ENGINEERING CHANGE ORDER

BOARD NAME <u>TORRENT CCD Analog Front End (AFE)</u>	ECO# TRNT-025	DATE <u>14OCT2011</u>
BRD SERL# <u>030</u> REV <u> </u>	ART# <u> </u>	
PN# <u> </u> REV <u> </u>		REV <u> </u>
ASBLY# <u>TRNT-EL-04-0004</u> REV <u>B</u>	PCB# <u>TRNT-EL-04-1004</u>	REV <u>B</u>
BOM# <u>TRNT-EL-04-4004</u> REV <u>B</u>	SCH# <u>TRNT-EL-04-2004</u>	REV <u>B</u>
COGNIZANT ENGR <u>Peter Moore / Ron George</u>	APPROVD <u>Peter Moore</u>

REASON FOR MODIFICATION:

Optimization of AFE to bring performance within requirement boundaries.
Reference acrobat file AFE_RB_Review_pcm_r2.pdf for notes

Main Power

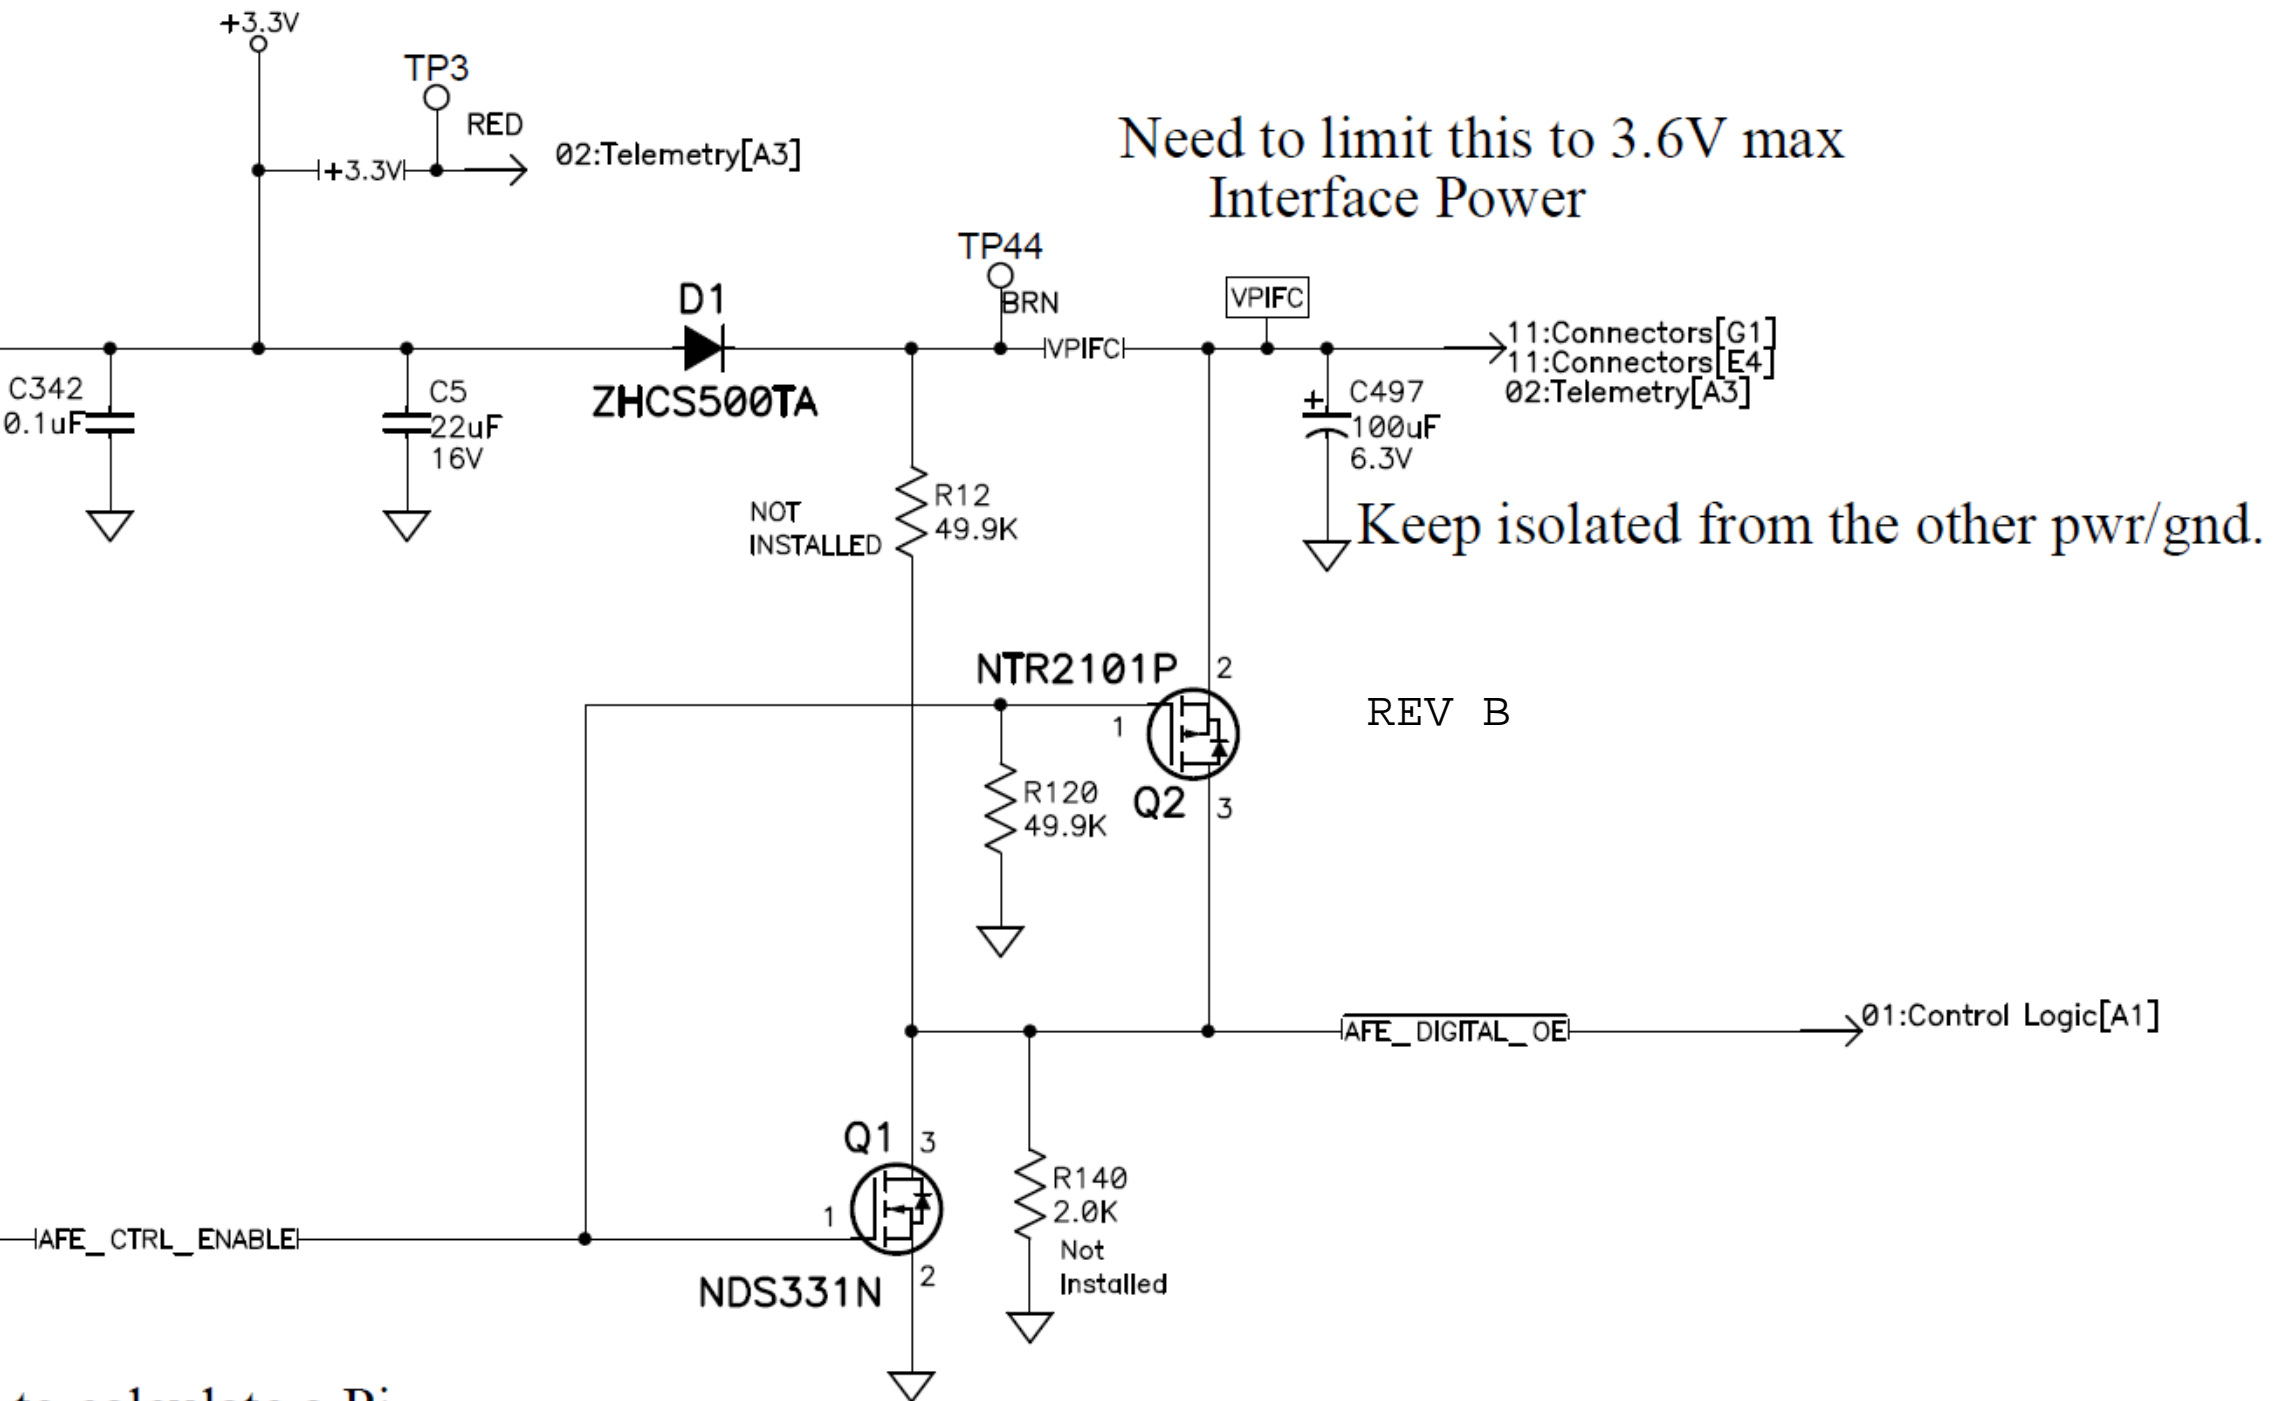
6. Add mosfet and resistor to VPIFC circuit on Pg 3 see detailed mark up
7. pg3 change text near TP48 to +31.6V / +2.74V
8. pg3 change text near TP53 to -3.3V / -32.2V
